PARTS BULLETIN

Original Issue Date: **4/95**
 Model: **8C, 10C, 12C**
 Market: **Marine**
 Subject: **End Bracket Bearing Change**

Figure 1. End Bracket

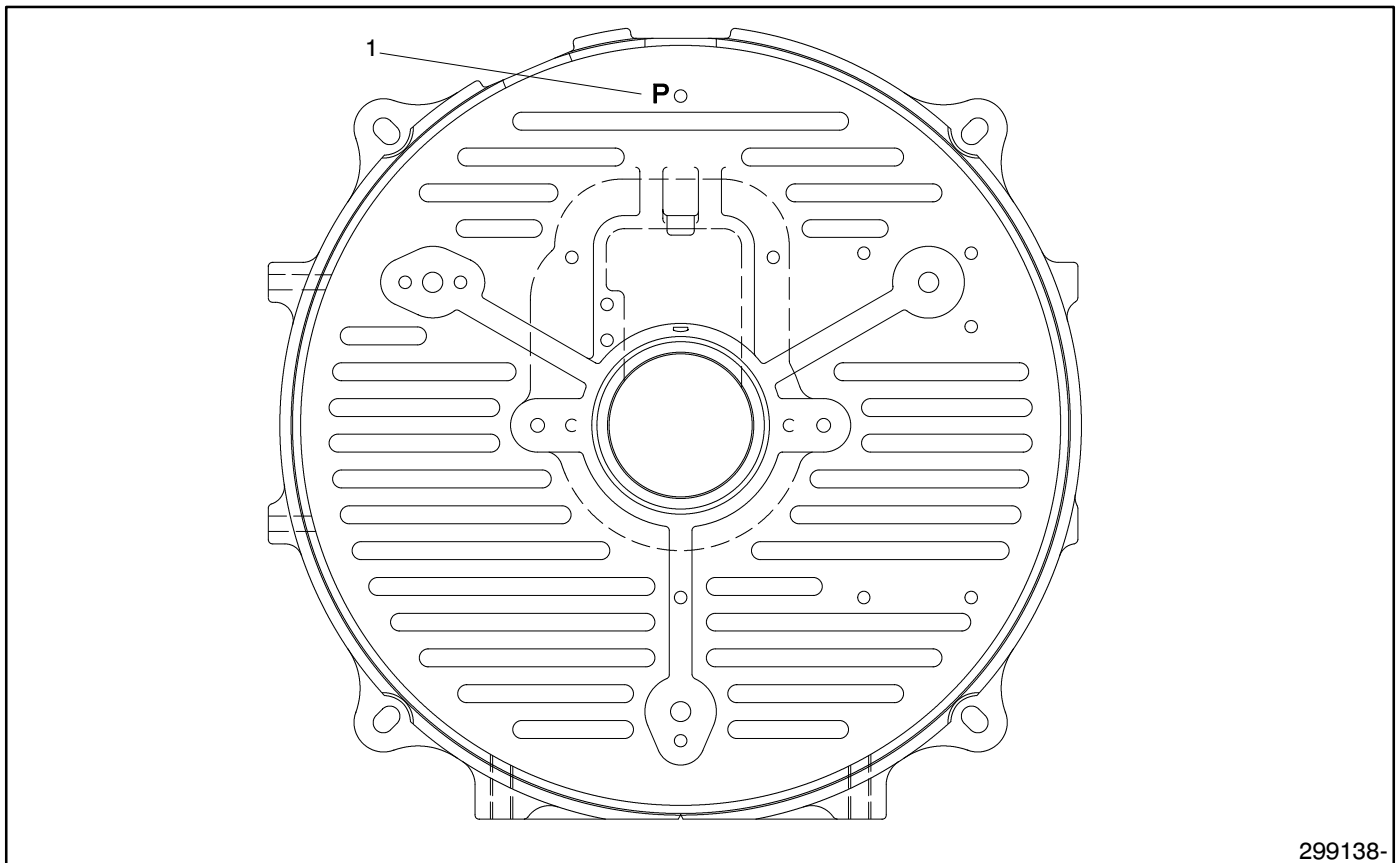
Kohler Co. has introduced a design change to improve end bracket and bearing life. New end brackets are identified by 1) a notched bearing which requires a pin and 2) a letter "P" stamped on the outside of the end bracket.

See Figure 1 for location. The end bracket and bearing are sold separately. Choose the correct bearing from the following table. This change will be reflected in parts catalogs as they are updated.

1. Approximate location of metal punch stamp

Generator End Bracket	Part Number	
	Bearing	New End Bracket
Stamped with the letter "P"	X-758-17	344128
Not Stamped with the letter "P"	X-758-1	-
